**Notice of changes to the contents printed on individual packaging boxes
for S-2XT21/T25 and SD-T35/T50 type Magnetic Contactors.**

Title: Notice of changes to the contents printed on individual packaging boxes for S-2XT21/T25 and SD-T35/T50 type Magnetic Contactors.

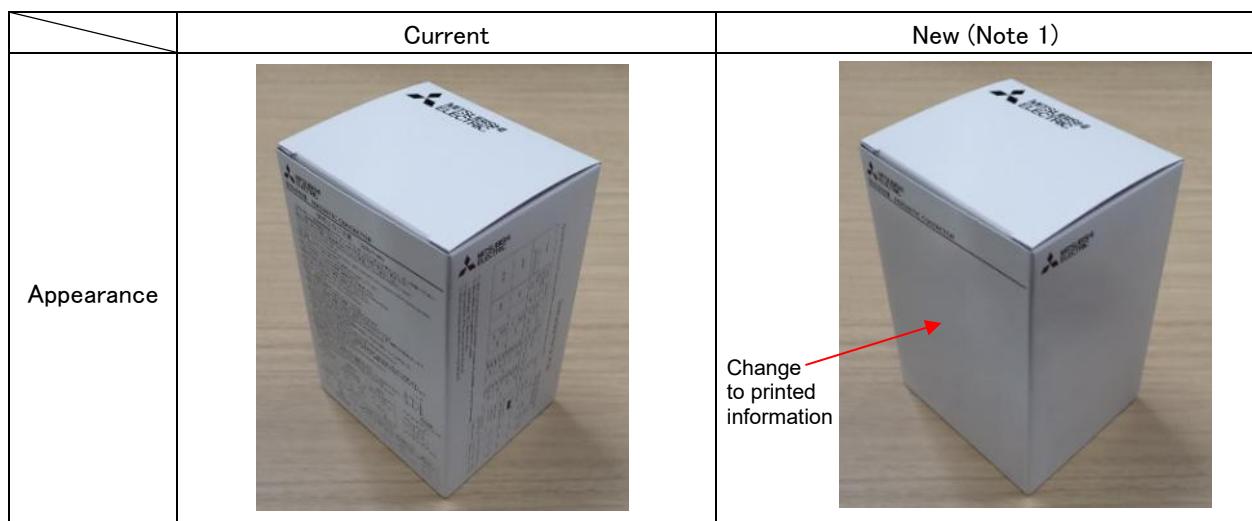
2. Changes

We will change the contents printed on the individual packaging boxes as follows.

3. Reason for Changes

To consolidate the contents printed on the individual packaging boxes into the Web instruction manual.
